TENNESSEE VALLEY AUTHORITY  
BROWNS FERRY NUCLEAR PLANT (BFN)  
UNITS 1, 2, AND 3

RESPONSE TO REQUEST FOR ADDITIONAL INFORMATION  
REGARDING BROWNS FERRY NUCLEAR PLANT INDIVIDUAL  
PLANT EXAMINATION FOR EXTERNAL EVENTS

***NOVEMBER 1998  
Revision 0***

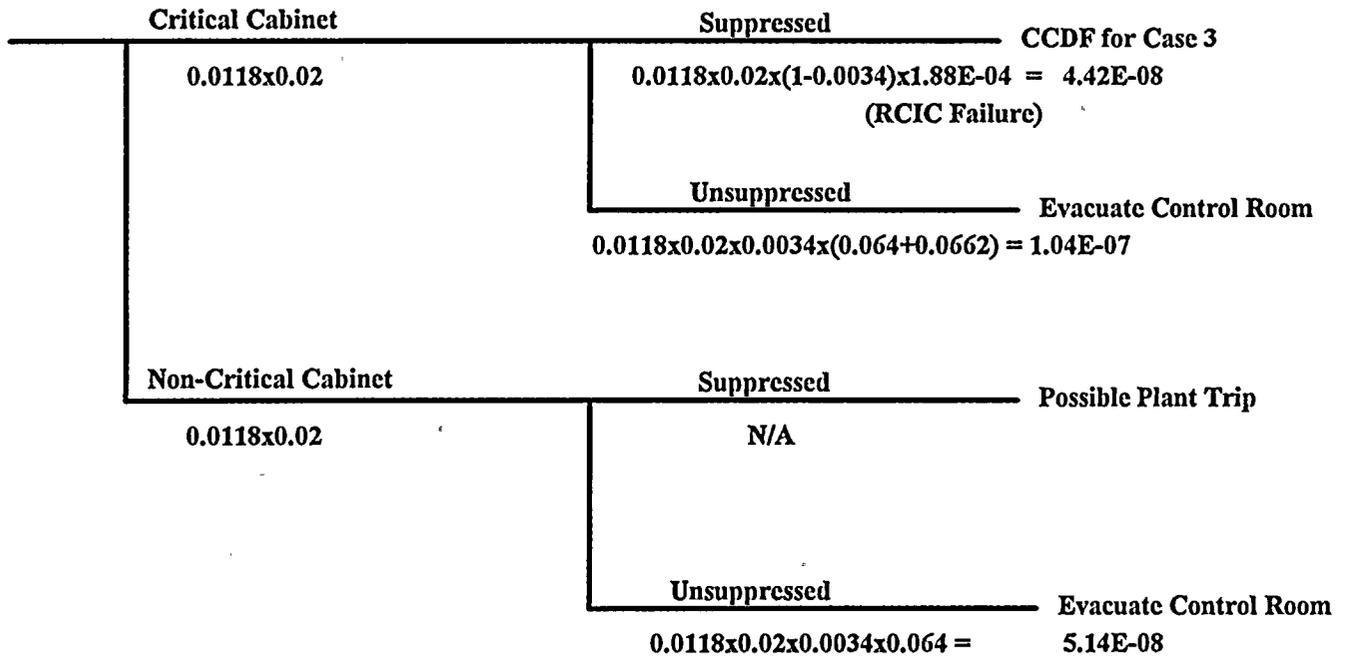
Please provide the detailed assumptions (including the assumed fire frequency, any frequency reduction factor, and the probability of abandonment) used in analyzing the MCR and justifications for these assumptions. In particular, if the probability of abandonment is based on a probability distribution for the time required to suppress the fire, please justify the parametric form of the distribution and specify the data used to quantify the distribution parameters.

These values are then multiplied by the panel ignition frequency (0.0118 per control room for the BFN IPEEE submittal, 0.00233 in NUREG-1521, multiplied by 0.02 to account for the panel population) and the suppression factor (0.0034). This generates a scenario frequency of :

$$\begin{aligned} &0.0118 \times 0.02 \times 0.0034 \times (0.064) && \text{for each non-critical cabinet} \\ &0.0118 \times 0.02 \times 0.0034 \times (0.064 + 0.0662) && \text{for each critical cabinet} \end{aligned}$$

- 5.14E-8 for each non-critical cabinet
- 1.04E-7 for each critical cabinet (unsuppressed)
- 4.42E-8 for each critical cabinet (suppressed)
- 1.48E-7 total for each critical cabinet

While each individual scenario remains screened, the total core damage frequency for all Control Room scenarios will exceed the FIVE cutoff of 1E-6 (i.e. 2.31E-6 for 45 non-critical panels and 7.40E-7 for 5 critical panels, or 3.05E-6 total).
